# Rainbow SkyReach (Pty) Ltd

# **SERVICE BULLETIN**

| IMPORTANCE     | HIGH                 |
|----------------|----------------------|
| AREA AFFECTED  | Engine Mount Adapter |
| SA/B NUMBER    | CH 012 06-2019       |

Figure 6 – Engine mount adapter rod

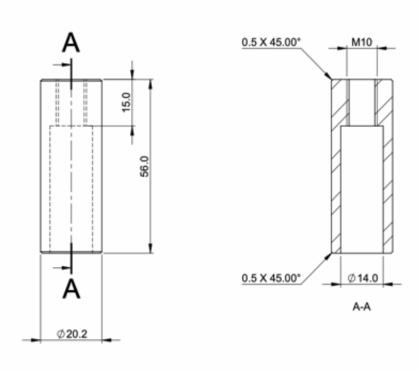
The reason for the bolt bottoming out and not fastening fully is due to a manufacturing defect in the machining of the rod before it gets welded to the rest of the adapter. For clarity a drawing of the rod is provided in Figure 6. The part is manufactured by drilling a  $\emptyset$ 8.9mm hole through the entire rod. The first 15mm is then threaded, and a larger  $\emptyset$ 14.0mm hole is machined in from the other side up to where it makes contact with the threaded section. In defective mounts the  $\emptyset$ 14.0mm hole's depth was incorrect and it does not reach the threaded section, as a result the bolt cannot extend past the 15mm threaded section.

To circumvent the problem a shorter length, Grade 8.8 Zinc Plated M10 bolt may be used which would not extend past the threaded section in the rod and would therefore not bottom out. At the time of publishing this service bulletin it had not been determined whether a M10 x 25mm or a M10 x 20mm would be the best replacement option. The factory will supply the best replacement option at no cost to the operator, we recommend using only approved bolts supplied by the factory since we cannot guarantee that the material and geometrical properties of your local hardware store bolts will be correct.

Figure 7 – Bolts requiring inspection

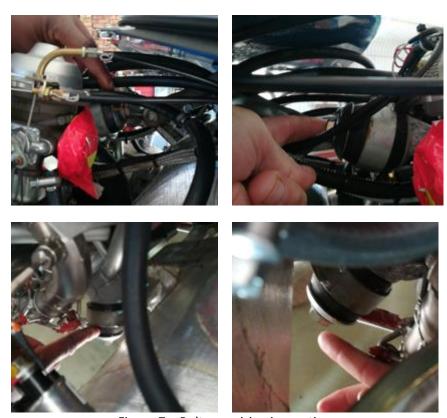
- All aircraft must be inspected visually by the operator before further flight. Steps 2 and 3 are only symptoms of the problem and if any of those two checks hold true, step 4 will still need to be checked to confirm that a defective engine mount adapter rod is the cause.
- 2. Check for a noticeable lateral shift in the engine by comparing the location of the front DZUS fasteners to the spinner.
- 3. Check for the oil filter housing chaffing on the lower oil radiator.
- 4. Check visually for any of the four engine mount adapter bolts which are not properly fastened, visible threads under the bolt head, as in Figure 4, would indicate that this is the case. The bolts to inspect are shown in Figure 7.

The two lower bolts may be removed as is, you may just have to remove the lower cowling to gain access to the engine mount. The upper bolts are slightly more complicated since the weight of the engine would need to be fully supported on an appropriate engine hoist before loosening the top bolts.

When inserting the new bolts ensure that the washers (and exhaust plate for the lower mounts) are inserted back in the same order that they were in when removed.
